6.2 Containment Systems

6.2.1 Containment Functional Design

6.2.1.1 Containment Structure

Figure 6.2.1.1-5 1

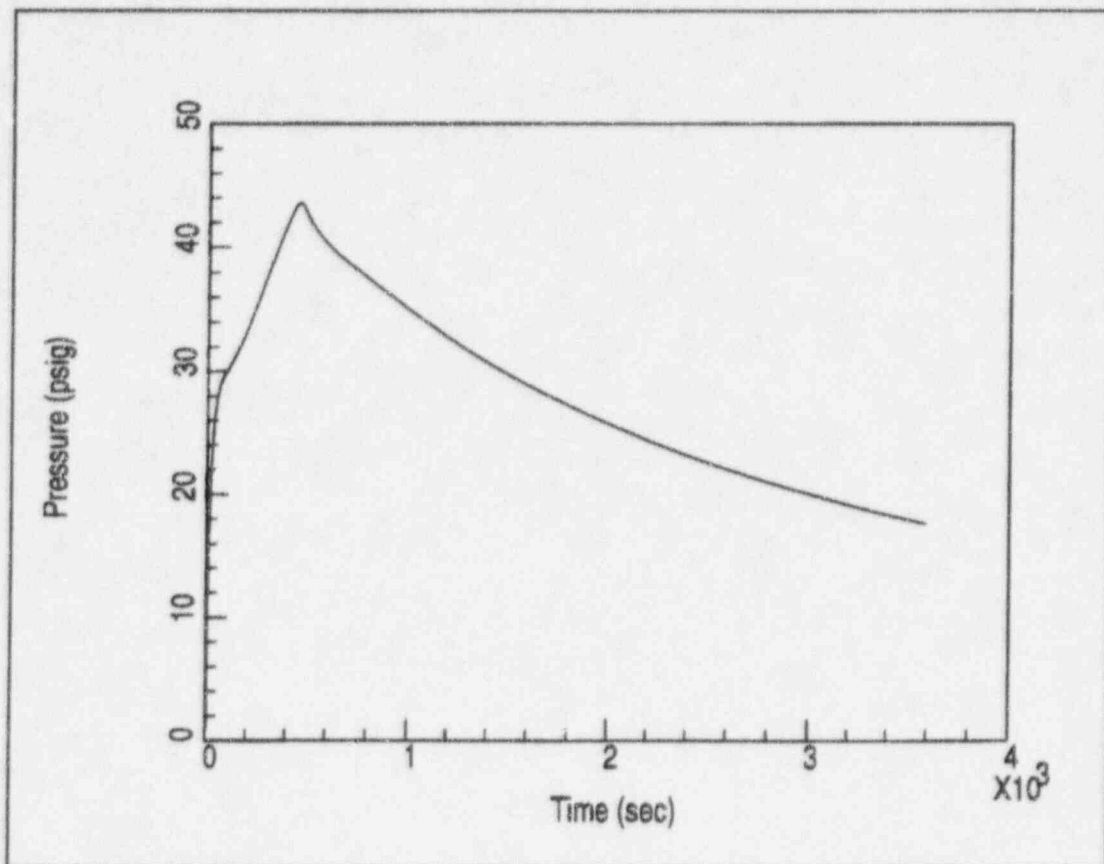
The containment pressure response for the peak pressure steam line break case is provided in Figure 6.2.1.1-1. The temperature response for this case is provided in Figure 6.2.1.1-2. Figures 6.2.1.1-3 and 6.2.1.1-4 provide the containment pressure and temperature response for the peak temperature steam line break case. Insert (A)

Figure 6.2.1.1-5

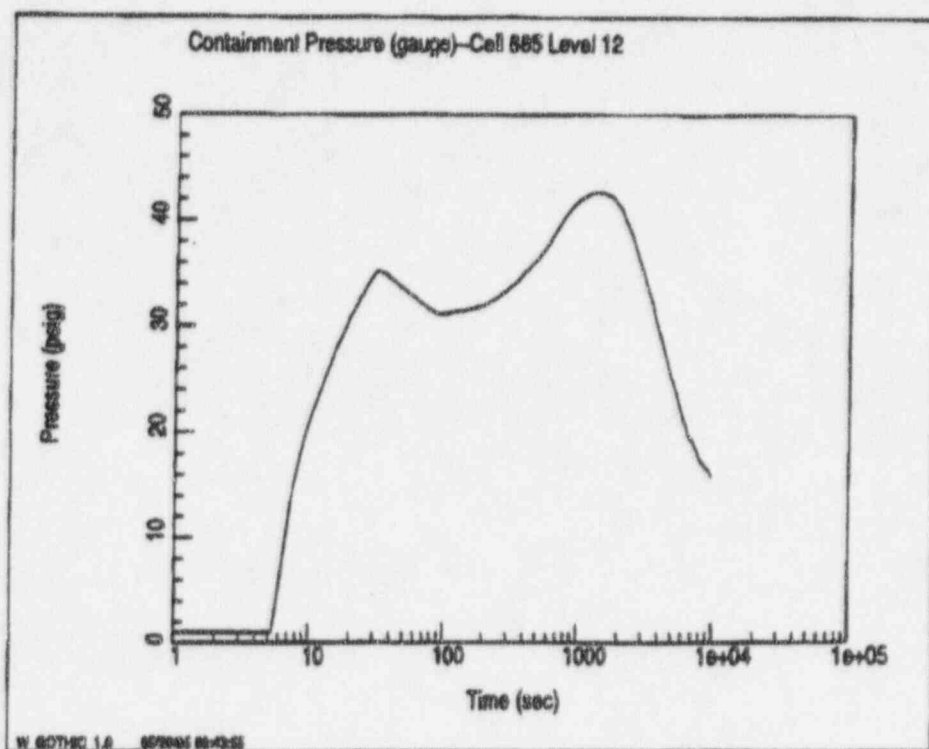
The containment pressure and temperature responses to a double ended cold leg guillotine are presented in Figures 6.2.1.1-5 and 6.2.1.1-6 for the distributed parameter model and Figures 6.2.1.1-7 and 6.2.1.1-8 for the lumped ~~2~~ parameter model. The lumped parameter model containment pressure and temperature response to a double ended hot leg guillotine break are presented in Figures 6.2.1.1-9 and 6.2.1.1-10.

Figure 6.2.1.1-4a⁷

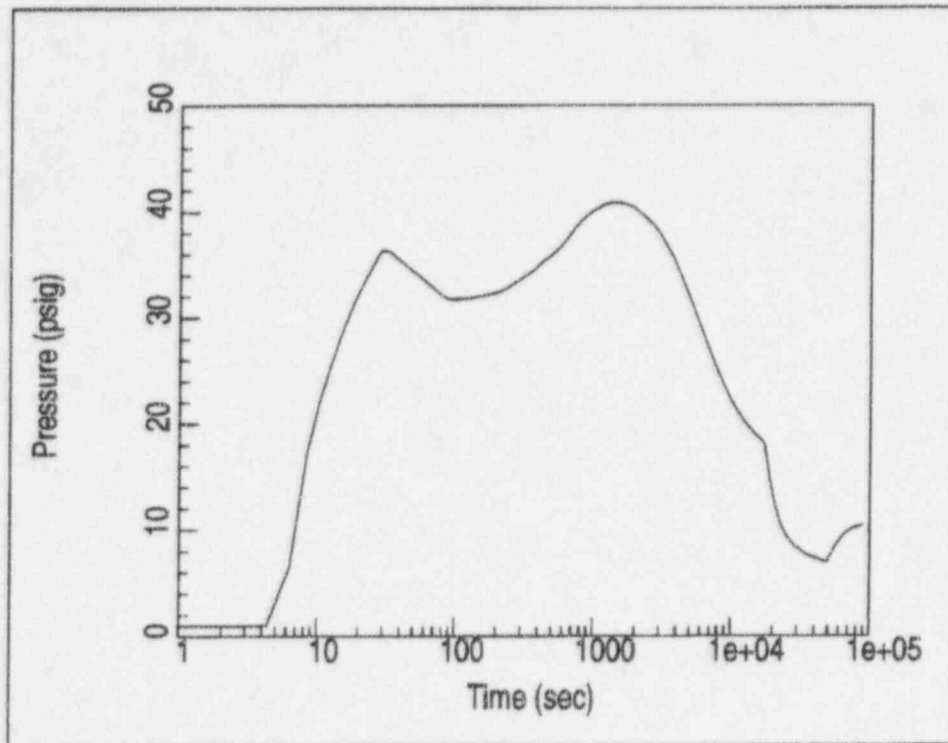
DECLG Containment ~~Temperature~~ vs. Time
Pressure

Figure 6.2.1.1/9

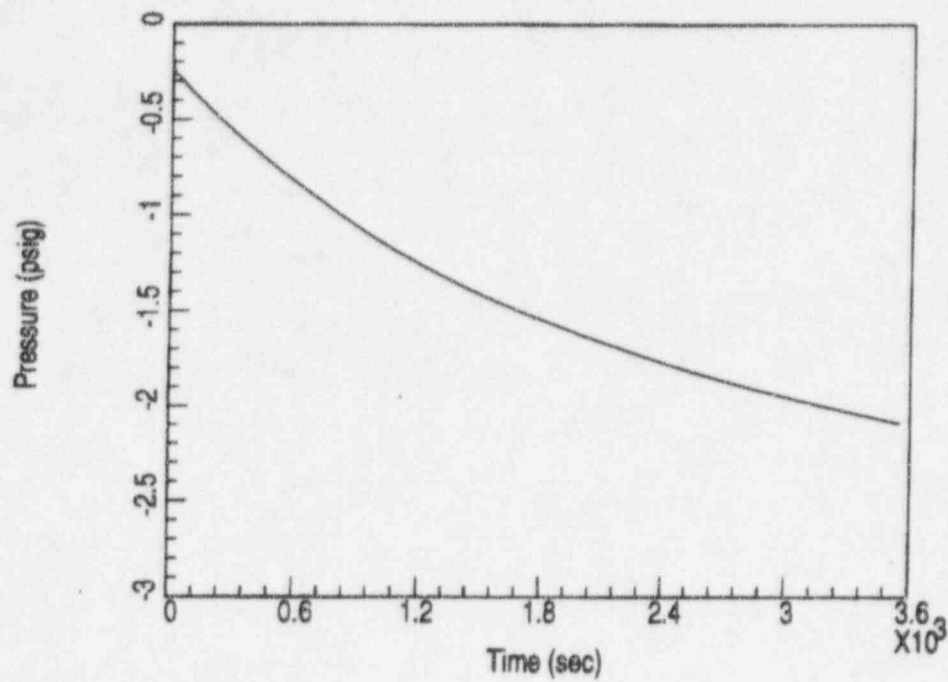
Certain design basis events and credible inadvertent systems actuation have the potential to result in containment external pressure loads. Evaluations of these events show that a loss of all ac power sources during extreme cold ambient conditions has the potential for creating the worst-case external pressure load on the containment vessel. This event leads to a reduction in the internal containment heat loads from the reactor coolant system and other active components, thus resulting in a temperature reduction within the containment and an accompanying pressure reduction. Evaluations are performed to determine the maximum external pressure to which the containment may be subjected during a postulated loss of all ac power sources. For the loss of all ac power sources, ASME Service Level C limits are applicable and a containment external pressure of 3.0-2.04 psid is permitted. 1

Figure 6.2.4

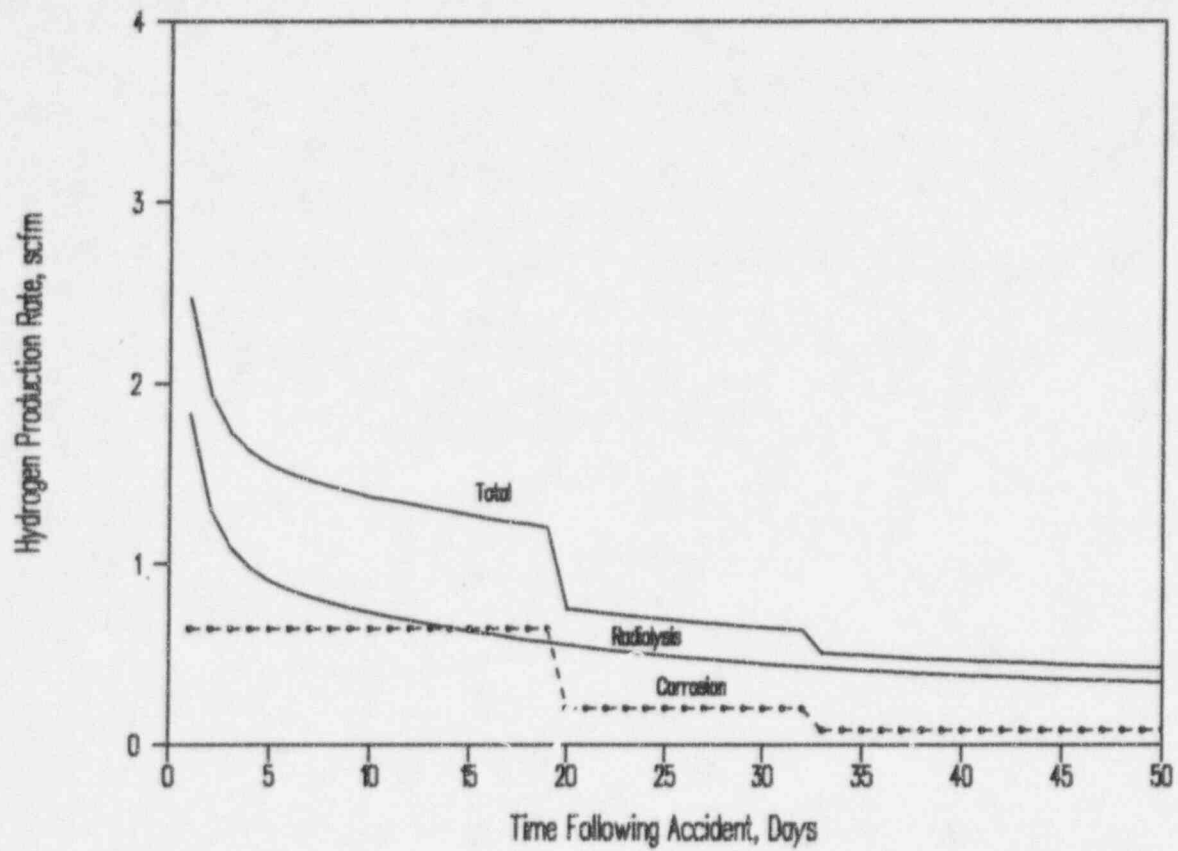
Production of hydrogen as a function of time is shown graphically in Figure 6.2.4-2² and the accumulation of hydrogen is shown in Figure 6.2.4-3³
